Cedar City

CITY COUNCIL WORK MEETING
JULY 21, 2021
5:30 P.M.

**CEDAR CITY
CITY COUNCIL AGENDA ITEM 21
STAFF INFORMATION SHEET**

REVISIONS		
DATE	DESCRIPTION	BY
7/2021	ADDED DETAIL W11A	J.A.S.

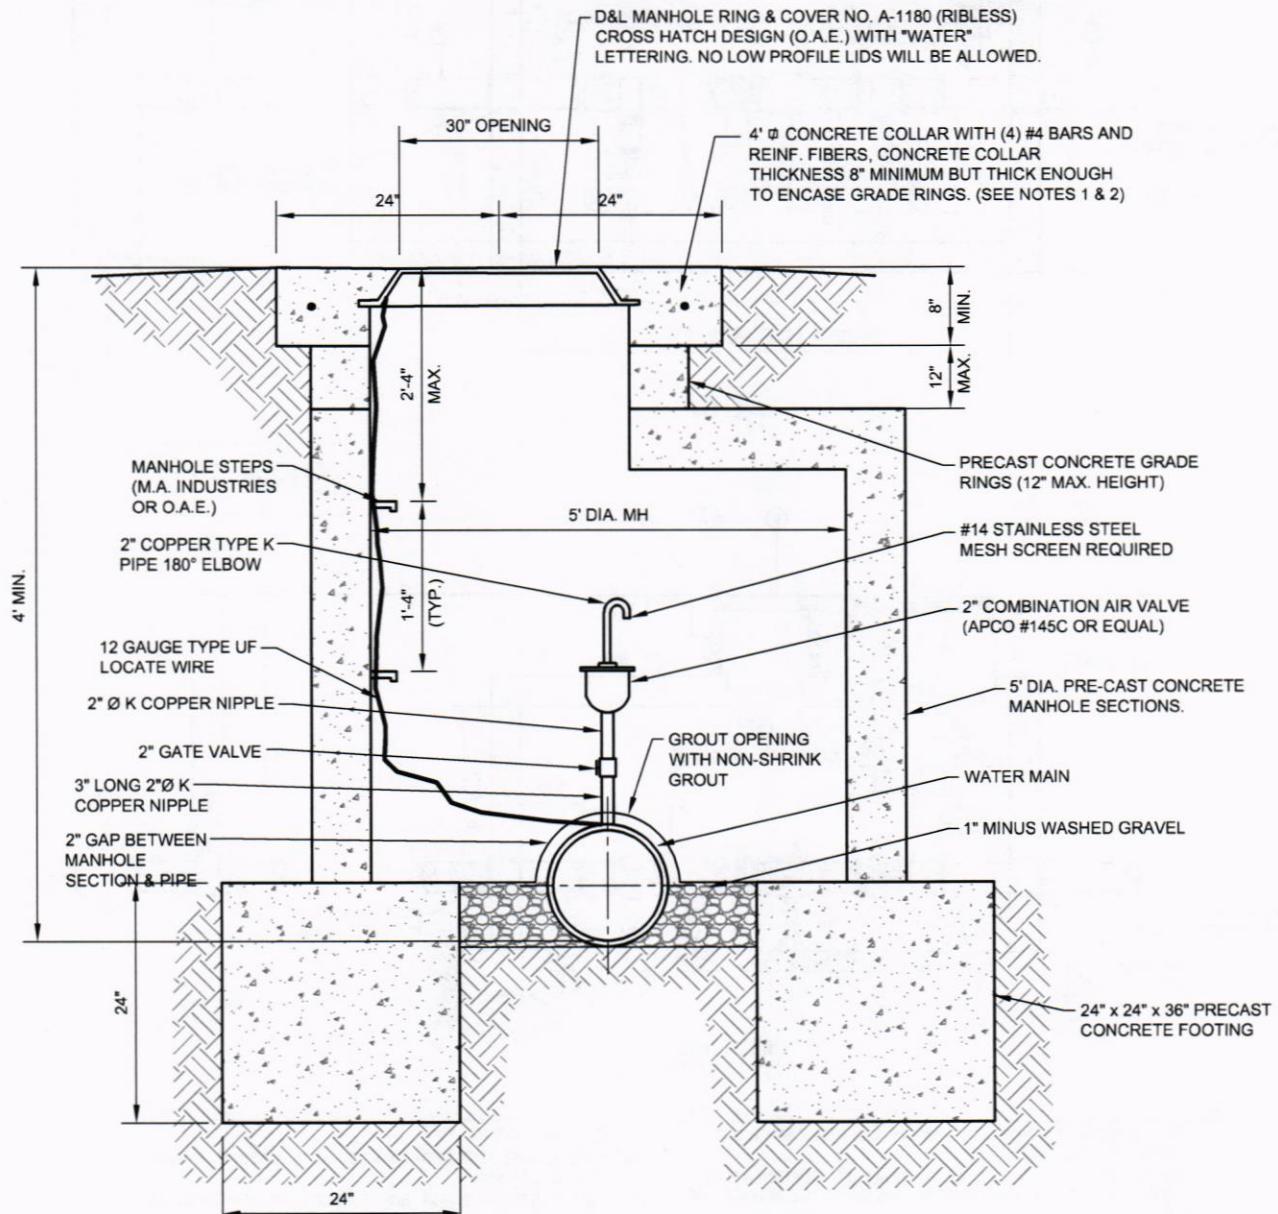
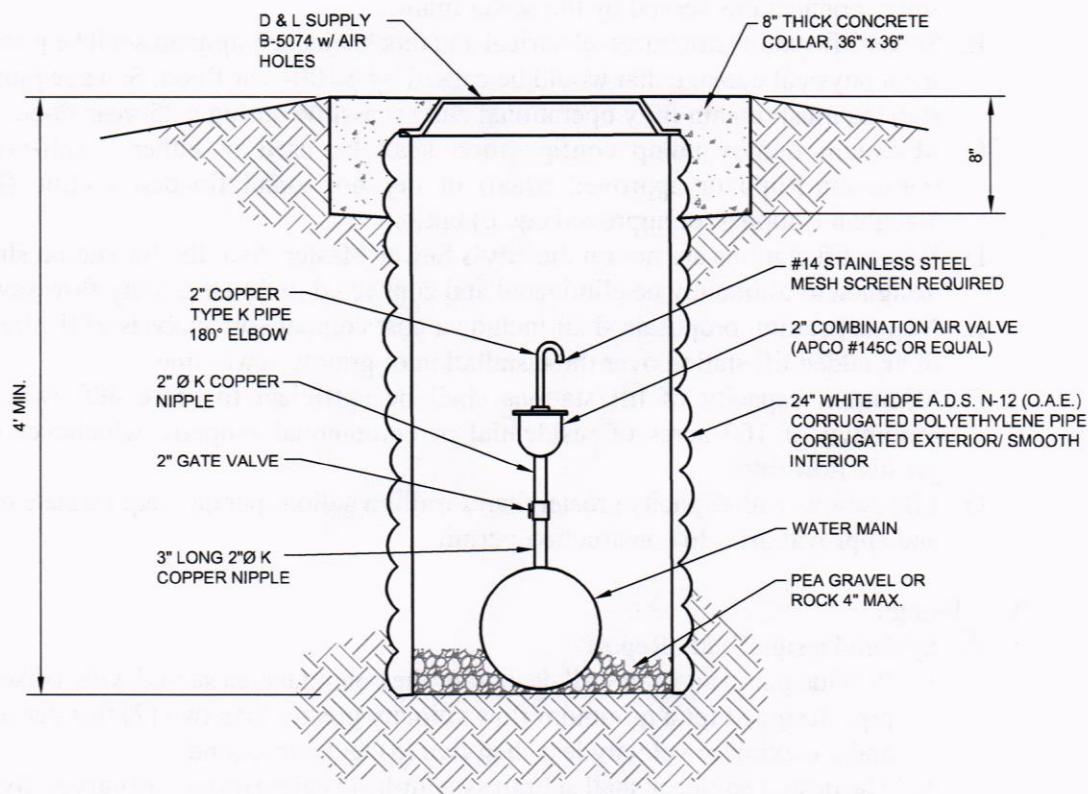
Added 3 additional leveling jacks to support the pipe.	Water	Increase
		Added a note clarifying that all pipe materials need to be rated for water system pressure.	Water	No change
38	Detail W11 & Detail W11A	Vault changed to a concrete manhole with ring and lid that is traffic rated. This detail will be used for air vac vaults in roadways.	Water	Increase
		Detail W11A added for air vac outside of roadways.	Public	No change
39	Section 3.2 – Note (1) for Table 3.1 (p. 3-1) and Section 3.3.3 (p. 3-4)	The minimum longitudinal street grade and curb & gutter grade is proposed to change from 0.50% to 0.40% slope . Cedar City is starting to see more development in flatter areas of the valley where it is difficult to achieve 0.50% slope. Pages 391 and 394 of AASHTO allow for a 0.30% minimum curb and gutter grade.	Public	Decrease
40	Section 4.2.1.III.A (p. 4-8)	Changed a sentence to only allow pre-cast manhole bases. Added a sentence stating that cast-in-place concrete bases will only be allowed if approved by the City Sewer Collections Division.	Sewer	Increase

Detail W-11 & W-11A: for air vacs. Currently, this detail only shows the standard meter barrel. They are getting lots in the roads. That barrel is not traffic rated, and they are proposing a concrete vault if in the road. If outside the road, they can still use the old detail. There are some text changes they are listed on here.
